RIDGE PORT NORTH 4TH ADDITION

RE: SUB 2001-20 -- Final Plat of Ridge Port North Fourth Addition

CASE NUMBER: SUB 2001-20 -- RIDGE PORT NORTH 4TH ADDITION

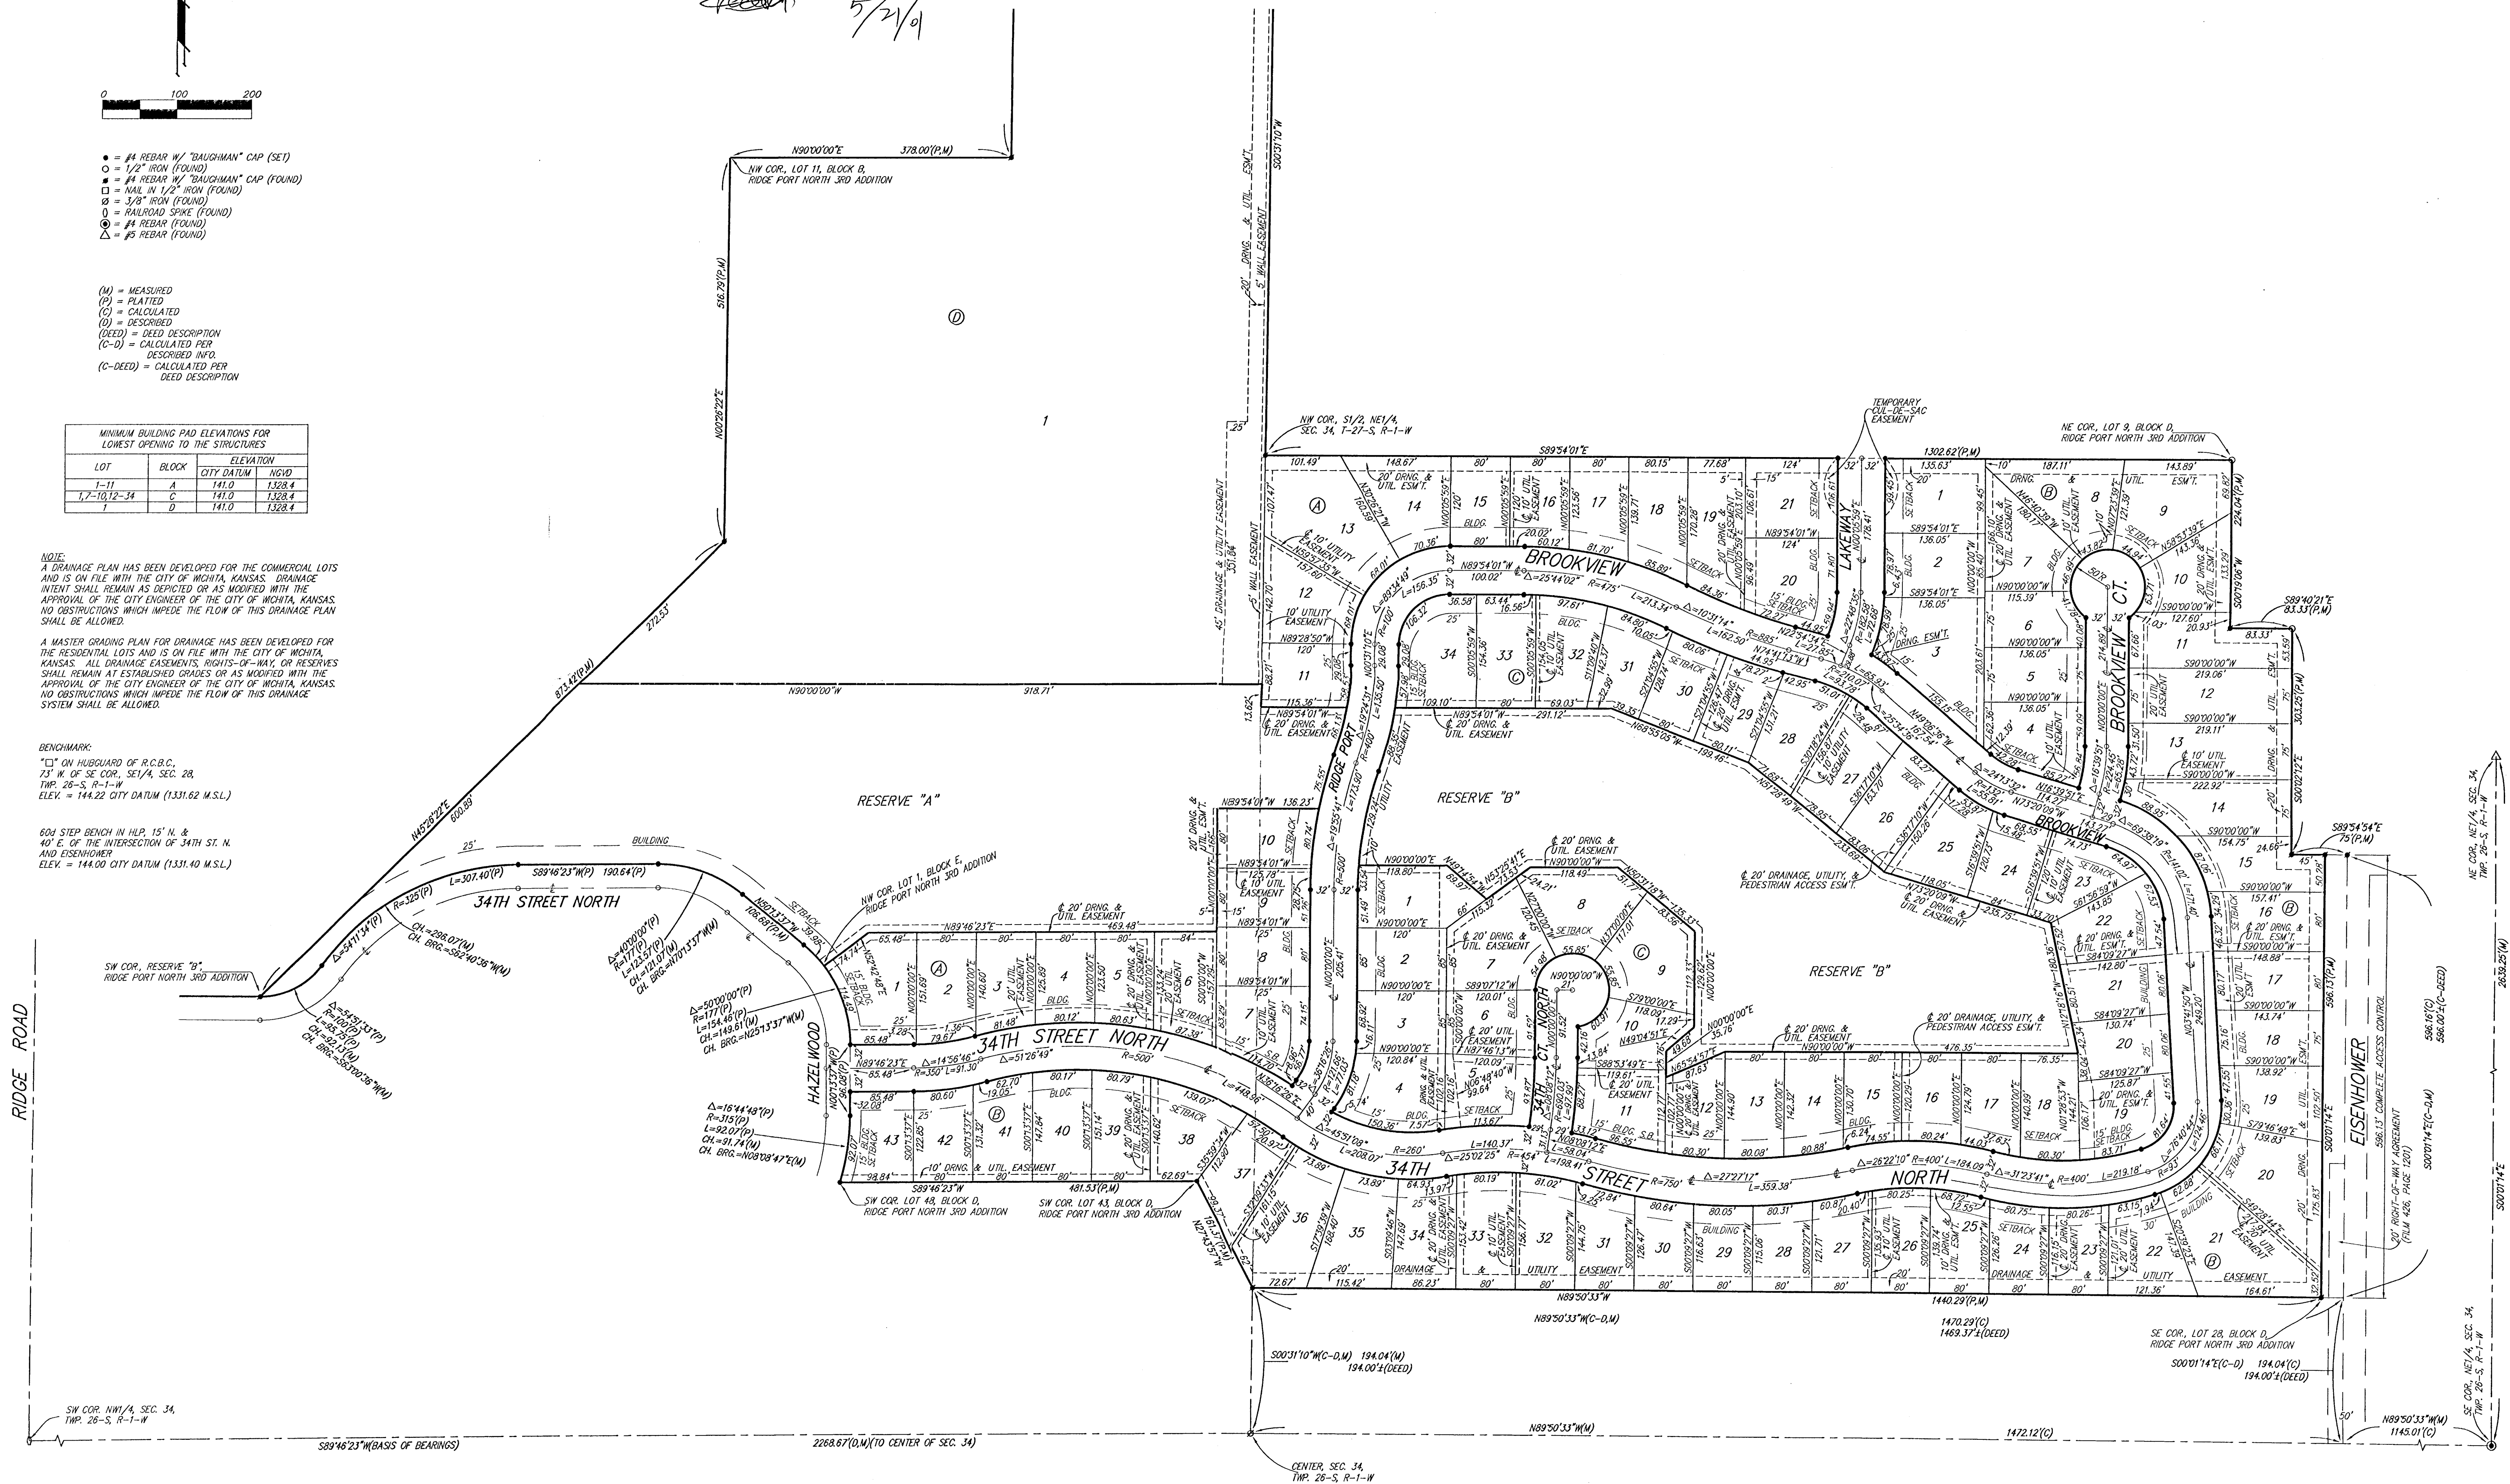
- D. City Engineering needs to comment on the status of the applicant's drainage plan. The drainage plan is approved.
- E. Provisions shall be made for ownership and maintenance of the proposed reserves. The applicant shall either form a lot owners' association prior to recording the plat or shall submit a covenant stating when the association will be formed, when the reserves will be deeded to the association and who is to own and maintain the reserves prior to the association taking over those responsibilities.

- G. City Fire Department needs to comment on the plat's street names. The street names are approved.
- H. The applicant shall guarantee the paving of the proposed interior streets. This guarantee shall include the installation of a temporary cul-de-sac for Lakeway. The guarantee shall also include sidewalks on one side of the loop street (34th St. North, Lakeway, Brookview and Ridge Port).

- I. County Engineering shall comment on the need for improvements to perimeter streets. The Subdivision Regulations requires paved access of perimeter streets between the nearest paved segment and the entrance to the subdivision. County Engineering has required a guarantee for the paving of 37th Street North to Lot 1, Block D.

- L. It is recommended that Reserve B be extended to 34th North Court and the loop street by access easements or by narrow strips of Reserve between the lots to increase its accessibility and usefulness for all homeowners in the Addition. The applicant has platted pedestrian access easements on the final plat between Lots 25 and 26 and between Lots 15 and 16.

- M. The bench mark description needs to be corrected.
- N. The plat's text shall include language that a drainage plan has been developed for the plat and that all drainage easements, rights-of-way, or reserves shall remain at established grades or as modified with the approval of the applicable City or County Engineer, and unobstructed to allow for the conveyance of stormwater.

- V. The representatives from the utility companies should be prepared to comment on the need for any additional utility easements to be platted on this property. KGE requests additional easements.
